2020 Corvette: GM TechLink: Removal of Corvette Z51 Spoiler

Removal of Corvette Z51 Spoiler

GM TechLink

Fig. 15

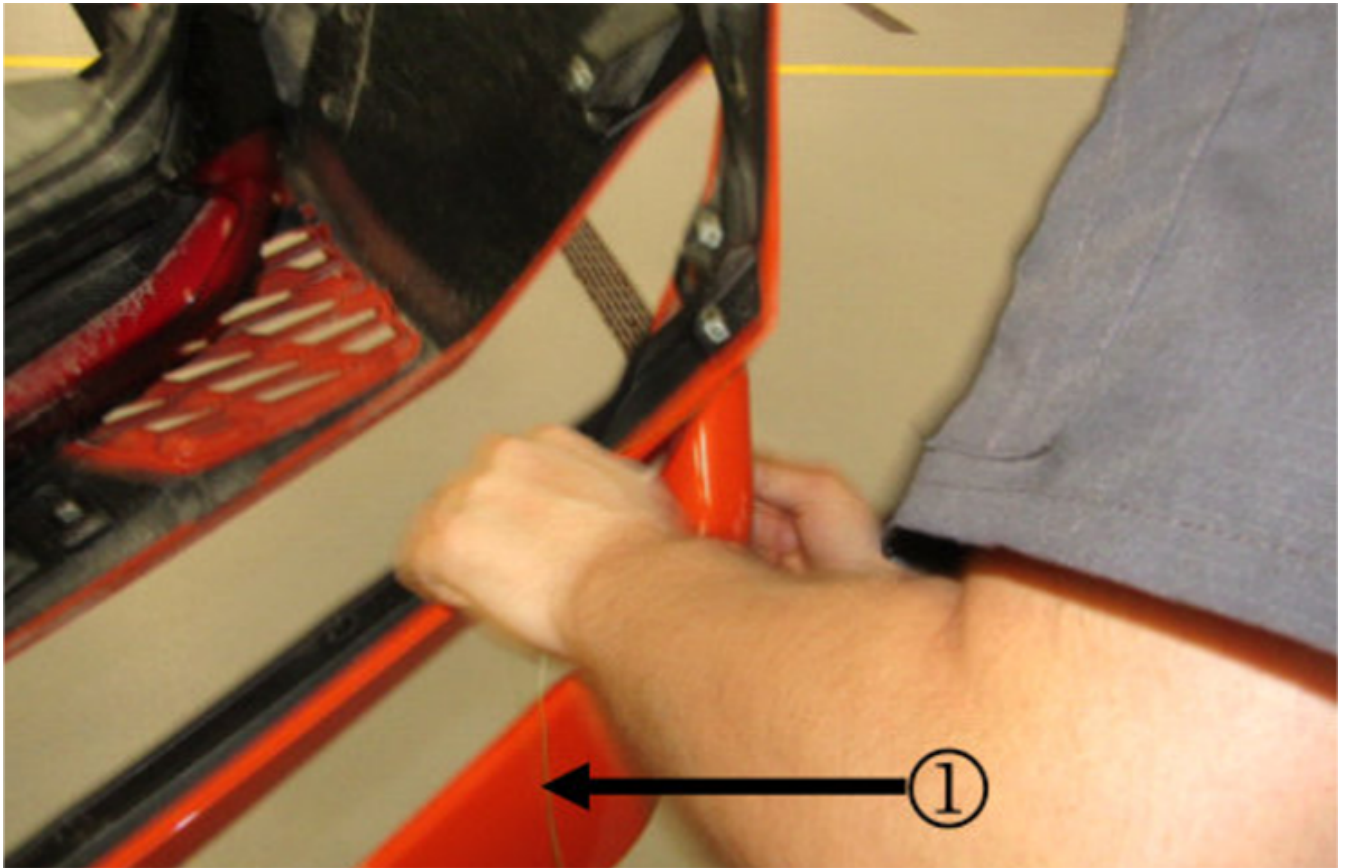
2020 Corvette Stingray models equipped with the Z51 Performance Package feature a rear spoiler that adds downforce to improve high-speed stability. (Fig. 15) If the Z51 spoiler is to be replaced with the high wing accessory spoiler, there may be some concern about applying heat to soften the two-way tape retaining the spoiler without damaging the rear fascia paint. The fascia paint may not be able to withstand high heat generated by a heat gun.

Fig. 16

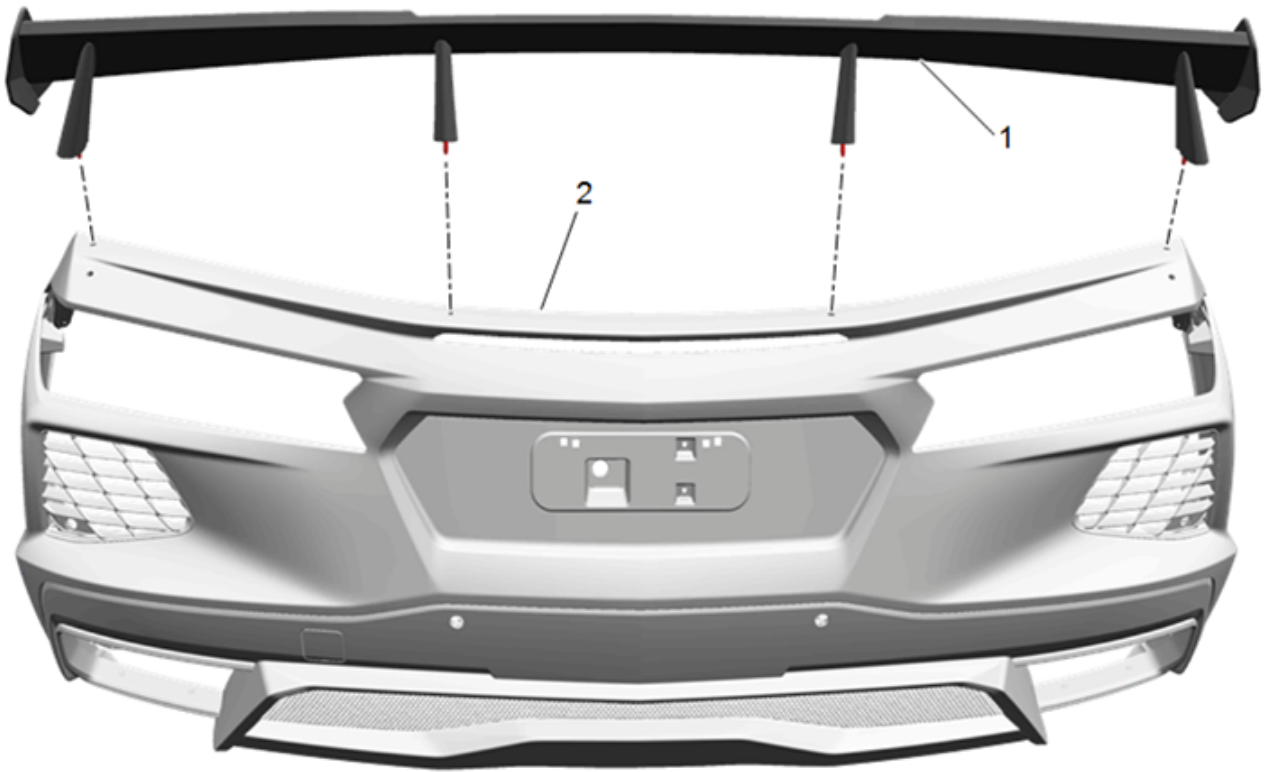
To remove the Z51 rear spoiler, it's recommended to use 50 lb. test monofilament fishing line. Position the line (Fig. 16, #1) between the spoiler and fascia and, with a sawing motion, move the fishing line through the two-way tape to remove the spoiler. Using the fishing line method will eliminate any possibility of damage to the painted fascia surface.

Do not use a heat gun, or attempt to pry the spoiler off the fascia with a plastic, metal or wood trim removal tool, in order to loosen the adhesive tape.

The installation instructions for Rear End Spoiler Package Installation (Fig. 17) in the Accessories Manual in the Service Information have been updated to eliminate the use of a heat gun to soften the two-way tape. Follow the updated installation instructions and do not use a heat gun during the removal process.
